DESIGN REVIEW BOARD REGULAR MEETING

Wednesday, February 11,
2026
6:00 p.m.

Subject: 26-01-DRB - 119 Union Avenue

Subject: 26-02-DRB - 330 Avenue D

C.3 Storefronts

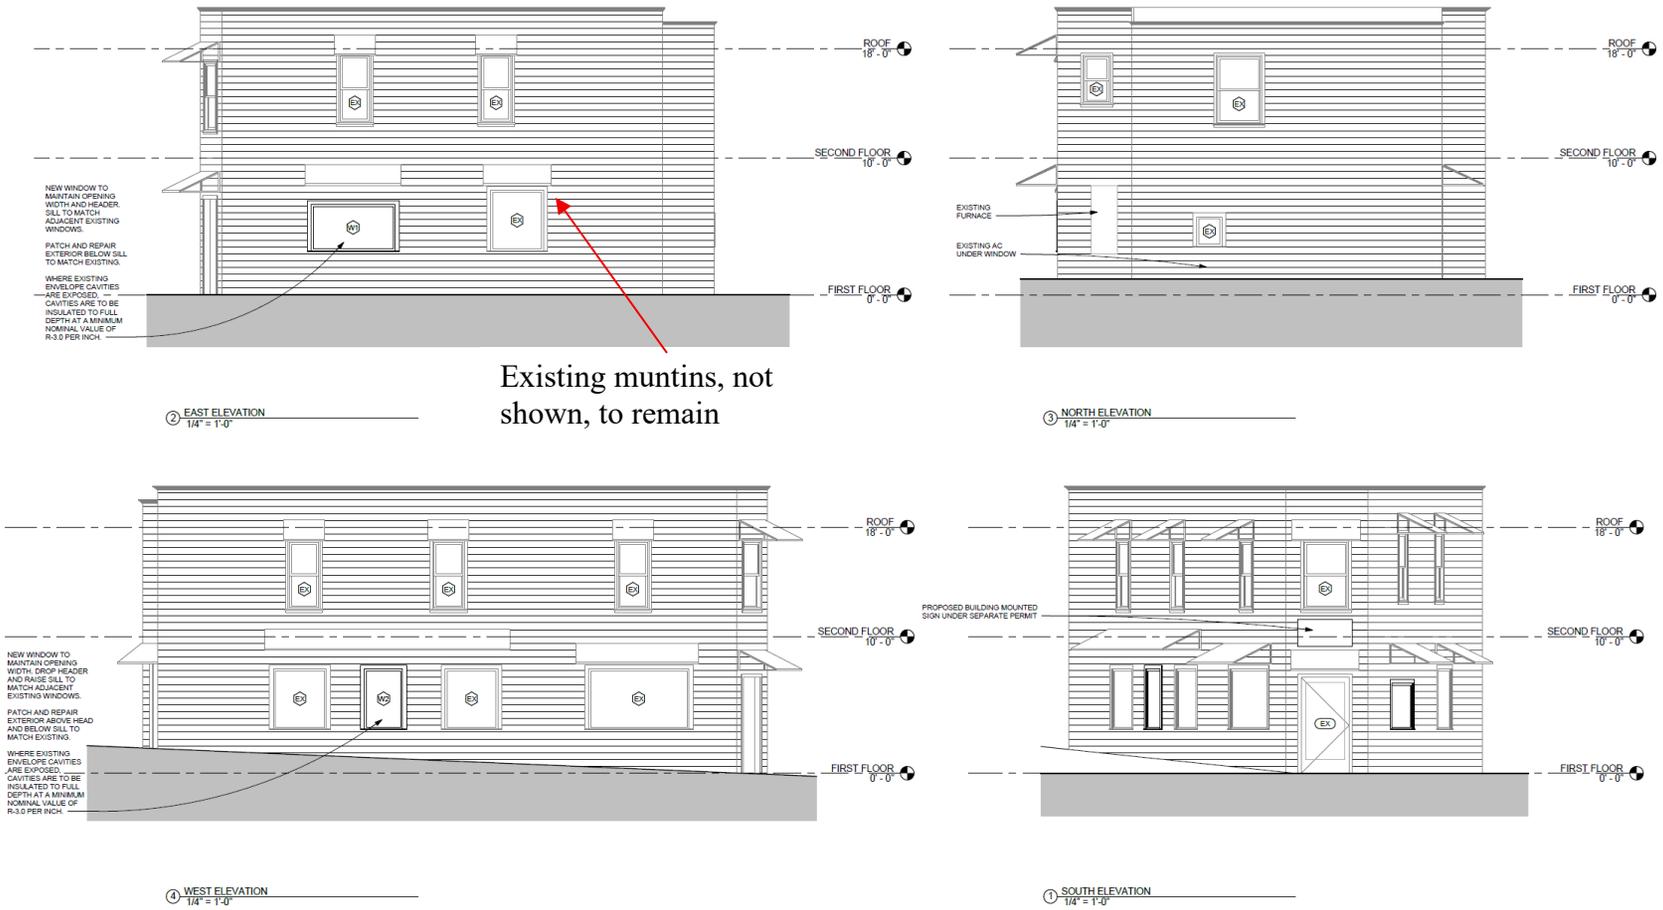
The subject building does not appear to have a traditional storefront. No changes are proposed that would affect storefront features, apart from converting side-facing doors to windows.

Under previous approval #06-02-DRB,
the double doors were installed:

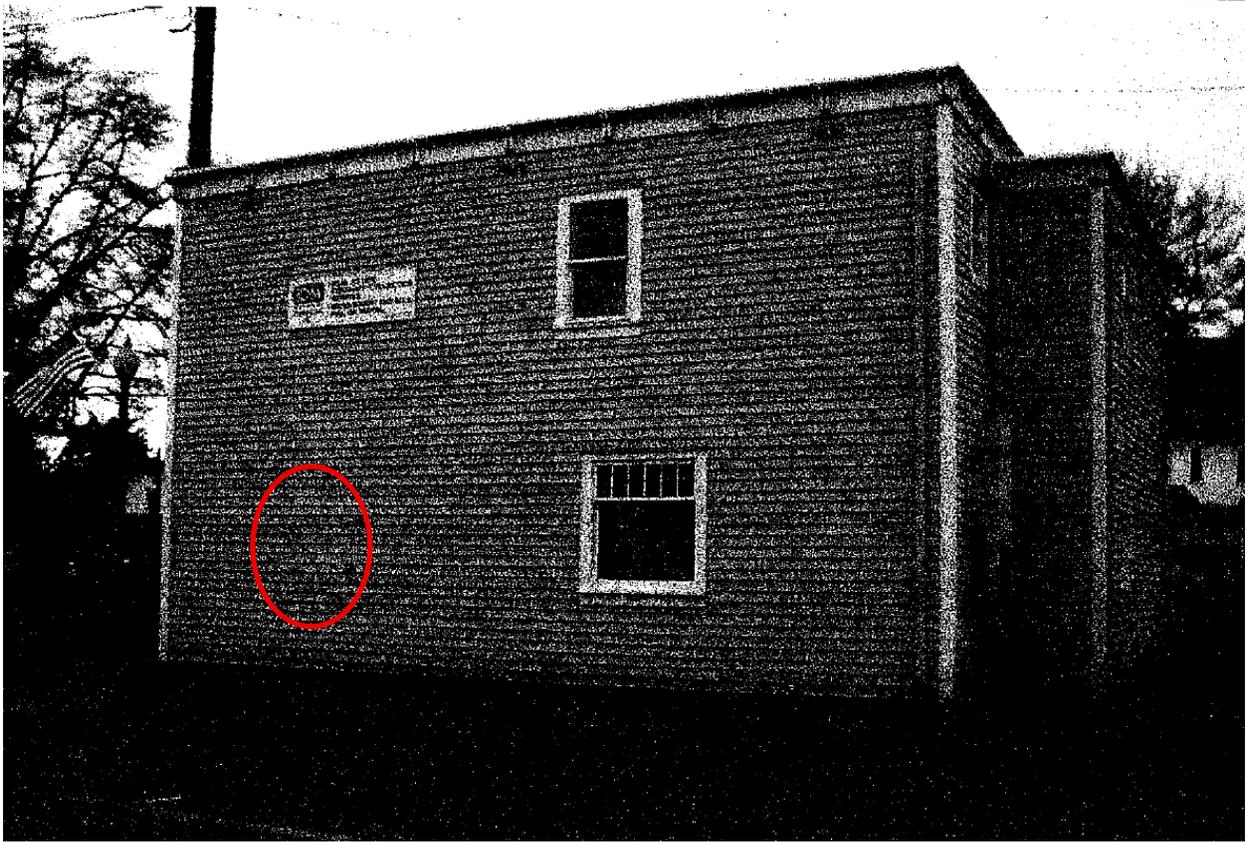
The double doors on the east facade were added to a previously blank wall in 2006 under DRB File #06-02-DRB. A historic photo of this facade prior to the approved modification is provided in the attachment. The current proposal will remove the doors and replace them with fixed windows, retaining the opening widths and the sill heights are proposed to match the adjacent windows. The header of the proposed window on the west facade will align with the adjacent windows while the existing header on the east facade will be retained as the sills will align. It is unknown whether the door on the west facade is original or was added later.

PROPOSED MAIN FLOOR PLAN- 42 SQ. FT. (ADDITION)

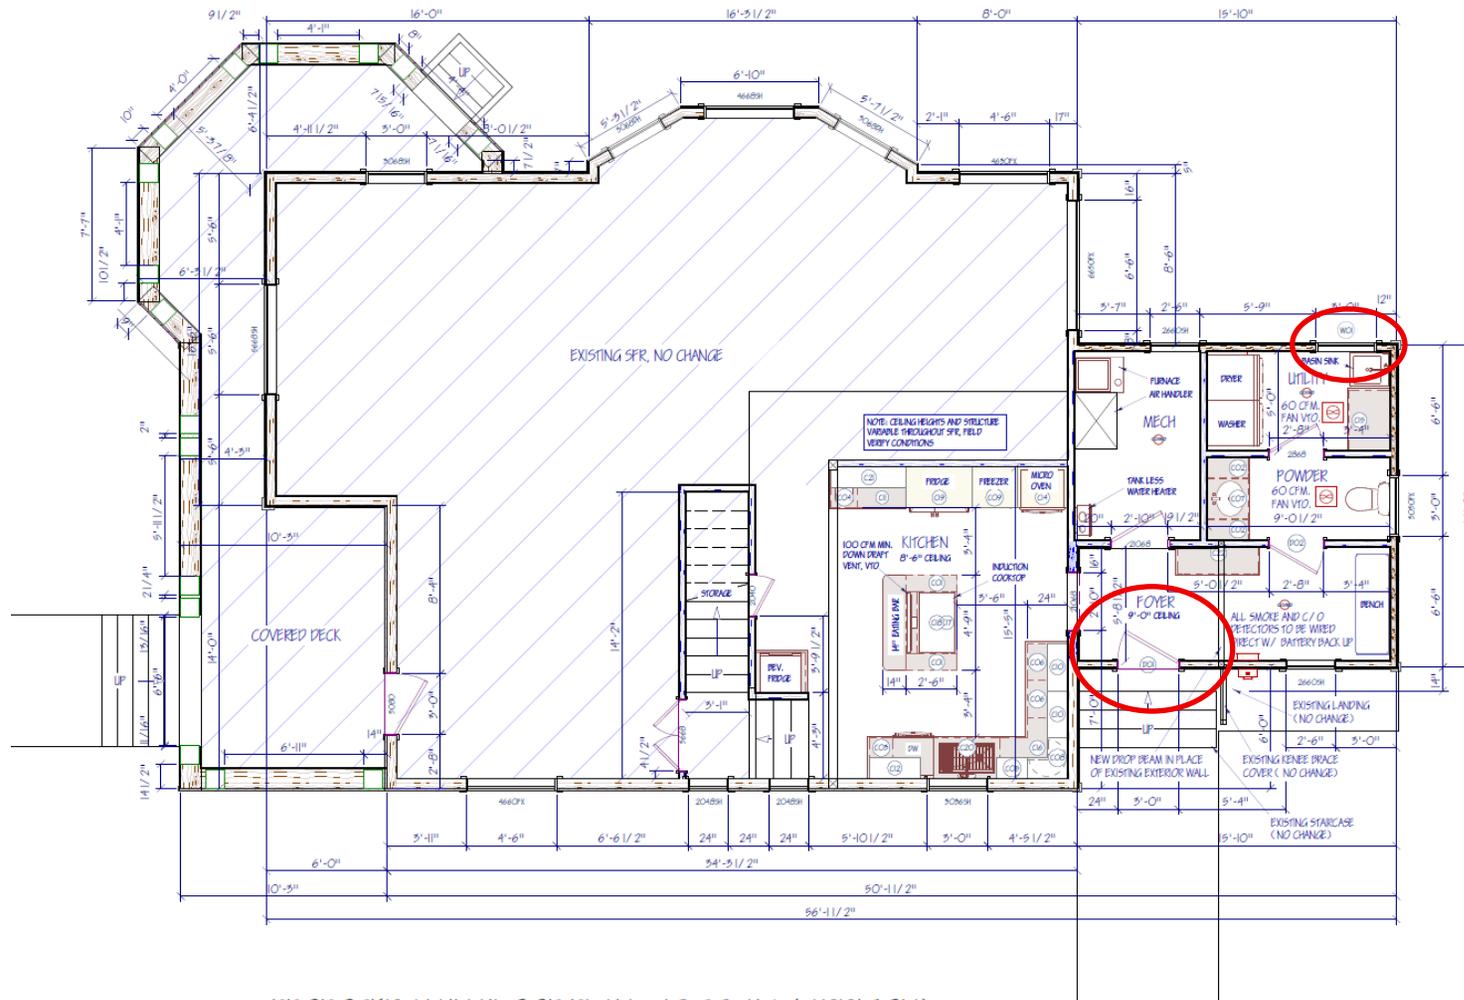
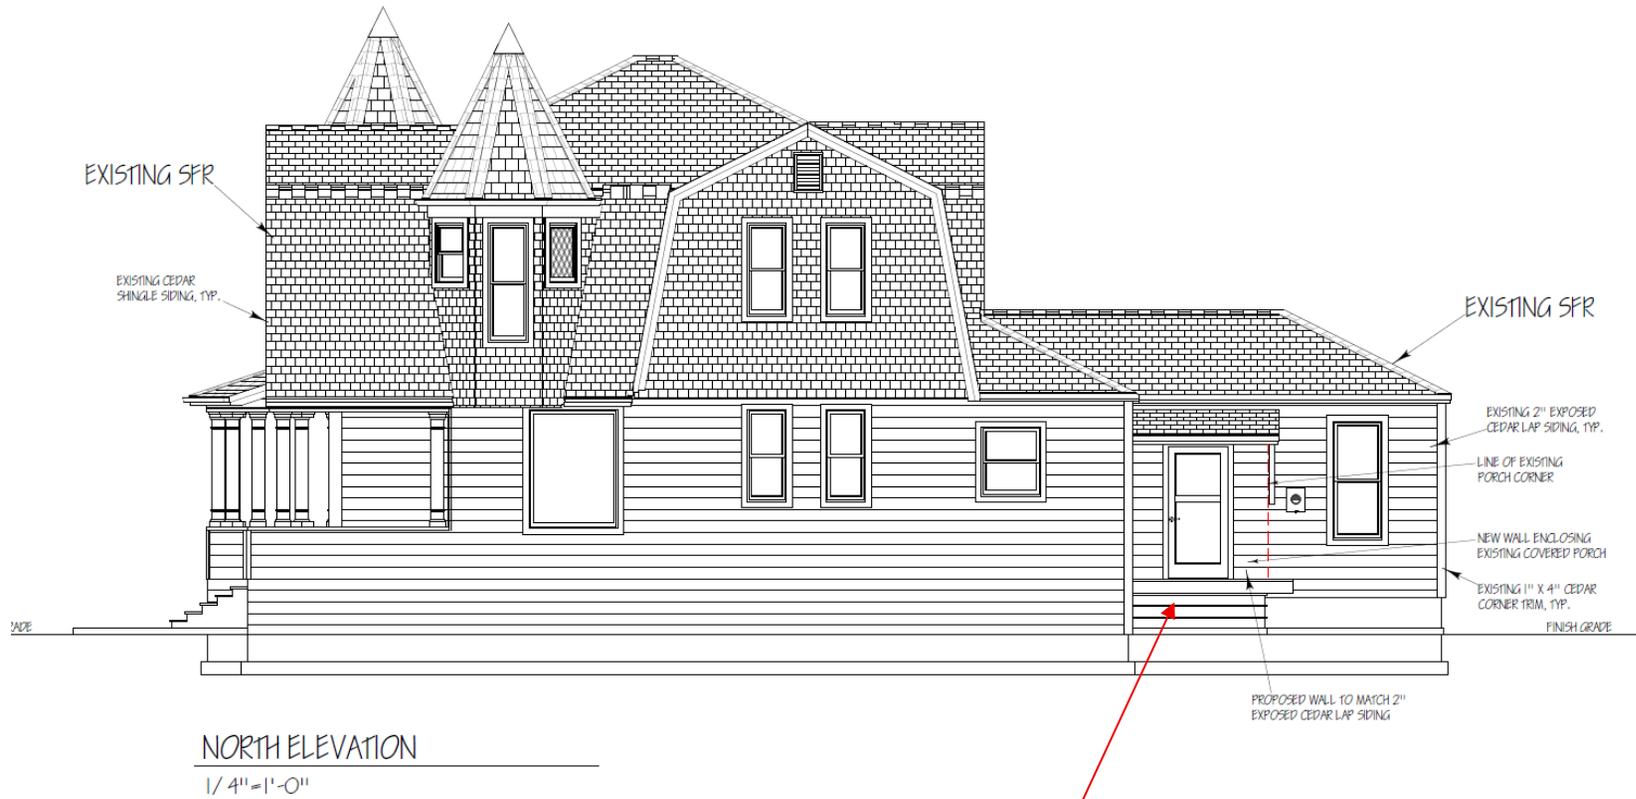
<p>C.4 Windows</p> <ol style="list-style-type: none"> a. When present and intact, existing windows shall be maintained and preserved in their original size, location, design, and proportions. b. New and replacement windows shall appear to be set back from the exterior building plane and finished with trim elements that are appropriate for the building. The use of vinyl windows is discouraged. c. New window openings shall not be added on the primary façade. d. Filling in or altering the size of historic window openings on the primary façade is not appropriate. 	<p><i>The proposed window enlargement is not visible from the street and faces inward toward the private yard. The Board should consider whether the proposal meets the intent of the standard.</i></p>

<p>e. Mullions and muntins shall be vertically proportioned. False muntins shall not be used.</p> <p>f. The original position, size, number, and arrangement of windows shall be retained in a building wall.</p>	
<p>C.6 Building Elements</p> <p>a. Architectural detailing may include trimwork, moldings, gingerbread, vergeboard, bargeboard, eaves, brackets, corbels, knee braces, dentils, cornices, decorative shingles, columns, pilasters, balusters, or any other decorative or character-defining feature.</p> <ol style="list-style-type: none"> 1. Architectural detailing shall not be removed or changed if original to the building. 2. If possible, architectural features shall be repaired rather than replaced. If replacement is necessary due to significant deterioration, the appearance, profile, and texture of the original materials shall be approximated in the replacement. 3. New architectural detailing may be added to a building if historic evidence indicates it is consistent with the original building or buildings of similar design and age in the surrounding area. 	<p><i>The proposal will enclose the covered entry and reuse existing trim, door, and siding. The door trim features a wide cornice with crown piece, which can be considered a character-defining feature that will be preserved and reused.</i></p>

<p>C.9 Doors and Hardware</p> <ol style="list-style-type: none"> a. Original or historic doors and hardware shall be maintained and preserved. If replaced, replacement shall be of a similar design to the original, to the extent possible. b. Wood is the preferred material for doors. Dark and painted metal is acceptable. Bright or shiny finish metal, fiberglass, and plastic shall not be used. c. Metal used for exterior hardware shall be dark without a bright or shiny finish, with the exception of copper and copper alloys (including brass and bronze). d. Hardware shall be traditional and historic in character. 	<p><i>One of three existing exterior doors and its hardware is proposed to be reused. The applicant states a door of similar design would be used if a replacement is required.</i></p>

Applicant proposes to reuse one of the three existing exterior doors, as well as the existing trim and siding.
